Access Compliance Report Public Rights-of-Way (Pedestrian Signals)

Intersection ID: N/A	Main Street:	Cross Street: N/A	Location: N/A
ADA ID: D27DEB163532	Signal Type: One Push Button-Non APS	Overall Compliance: No	Severity Score: BTN 1: N/A BTN 2: N/A No BTN: N/A
Codes/Mitigation Info/Possible Solution		Field Measurements/Component Compliance

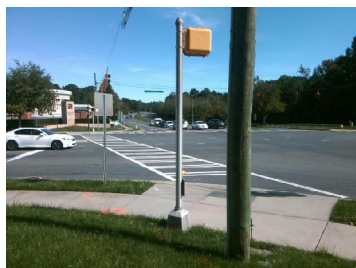
PROW/ADA: TMUTCD 4e.08, R404.2, R406.2

Possible Solutions: Replace Signal Push Button With APS Button on New Post. Remove & Relocate Sign.
